SAFETY RECALL CODE 0813 - SIDESTAND SWITCH

Buell Motorcycle Company has learned that certain 1996 through 1999 Buell motorcycles were built with a sidestand switch that could become inoperative. This condition could cause the engine to stall or quit when riding which could result in an accident. Accordingly, Buell Motorcycle Company is conducting a voluntary recall campaign to formally recall all potentially affected motorcycles.

This campaign involves all 1996 through 1999 S1 Lightning, S1 White Lightning, X1 Lightning, M2 Cyclone, S3 Thunderbolt and S3T Thunderbolt model Buell motorcycles manufactured between January 20, 1995 and April 21, 1999.

Figure 1. Original Sidestand Switch and Bumper

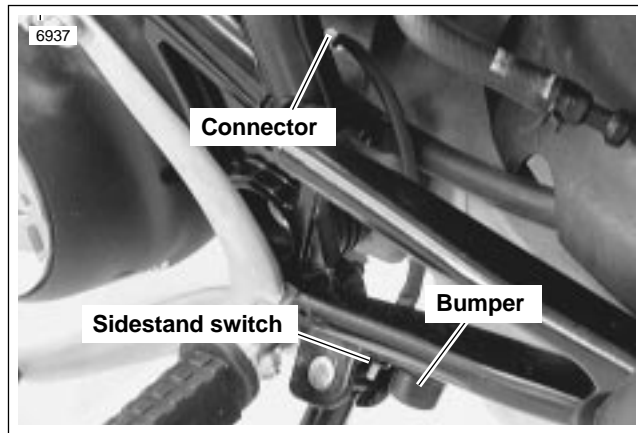
1. Disconnect negative battery cable.
2. See Figure 1. Unplug sidestand switch wiring from connector.
3. Remove switch from vehicle frame and discard.

Figure 3. New Switch Assembly

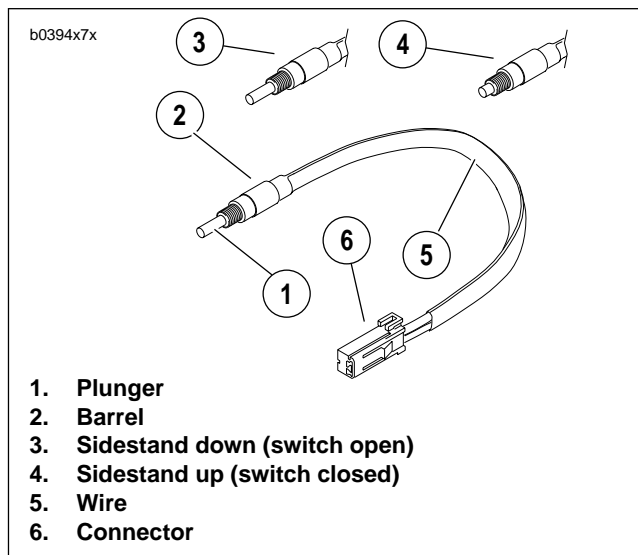
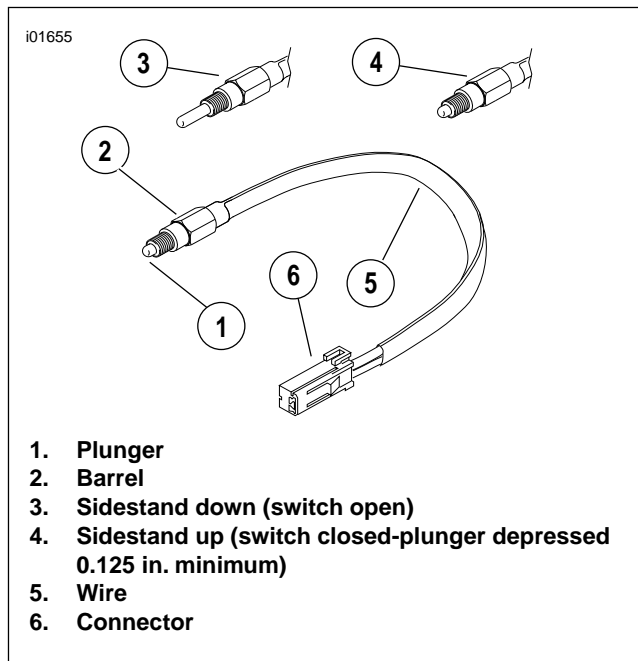
See Figures 1, 2 and 3. The current sidestand switch can be differentiated from the replacement one by noting the differences in the plunger. The current plunger is made of white plastic and has a flat tip. The plunger of the replacement switch is made of metal and has a round tip.

1. Thoroughly clean the switch frame mounting area and threads.
2. Install switch into frame so that plunger is facing down. Torque to 25-35 **in. lbs.** (2.8-4.0 Nm).

Figure 4. Dimension "A" Measurement

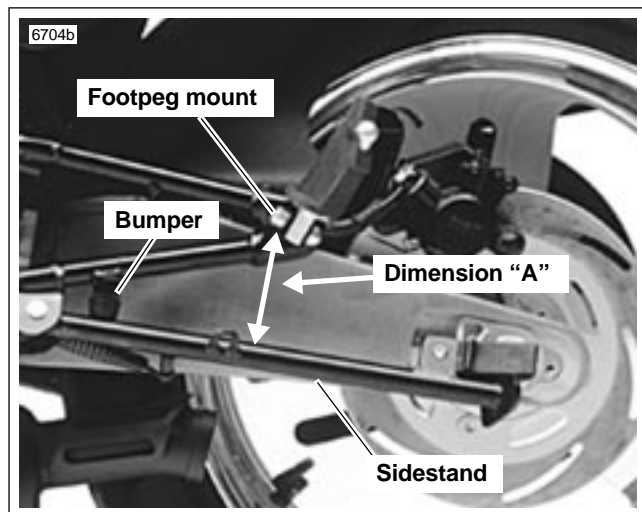
- See Figures 5 and 6. Dimension "B" is determined by measuring the distance perpendicular to the left outside surface of the swingarm to the sidestand dragger mount.
- See Figure 4. Dimension "A" is determined by measuring the distance perpendicular to the top side of the sidestand to the lower edge of the passenger footpeg front mount tab.

1. Remove and discard original sidestand bumper and spacer washers.
2. See Figures 4 and 5. Establish correct sidestand retraction angle by using either the new cylindrical bumper or the new conical bumper in conjunction with up to three spacer washers. The sidestand retraction angle is defined by Dimension "B". Dimension "B" must be within 0.500-0.625 in. (13-16 mm). Keeping Dimension "B" within specifications listed, measure Dimension "A". Dimension "A" must not exceed 3.125 in. (79 mm).
3. Using the bumper and washer combination determined in Step 2, place a small amount of LOCTITE THREAD-LOCKER 243 (blue) on the bumper threads and install it into the frame.
4. Hand tighten securely.

1. Remove and discard original sidestand bumper and spacer washers.
2. See Figures 4 and 5. Establish correct sidestand retraction angle by using either the new cylindrical bumper or the new conical bumper in conjunction with up to three spacer washers. The sidestand retraction angle is defined by Dimension "B". Dimension "B" must be within 0.500-0.625 in. (13-16 mm). Keeping Dimension "B" within specifications listed, measure Dimension "A". Dimension "A" must not exceed 4.5 in. (114 mm).
3. Using the bumper and washer combination determined in Step 2, place a small amount of LOCTITE THREAD-LOCKER 243 (blue) on the bumper threads and install it into the frame.
4. Hand tighten securely.

Figure 5. Dimension "B" Measurement

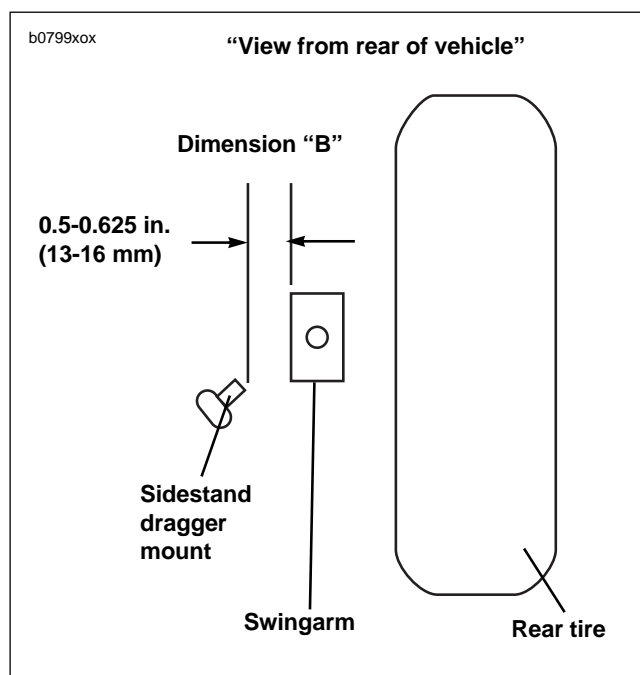
See Figures 3 and 5. The objective of this procedure is to obtain both a **minimum** sidestand switch plunger depression of 0.125 in. (3 mm) **and** a **minimum** sidestand/swingarm clearance (Dimension "B") of 0.5 in. (13 mm) when the sidestand is in the retracted position.
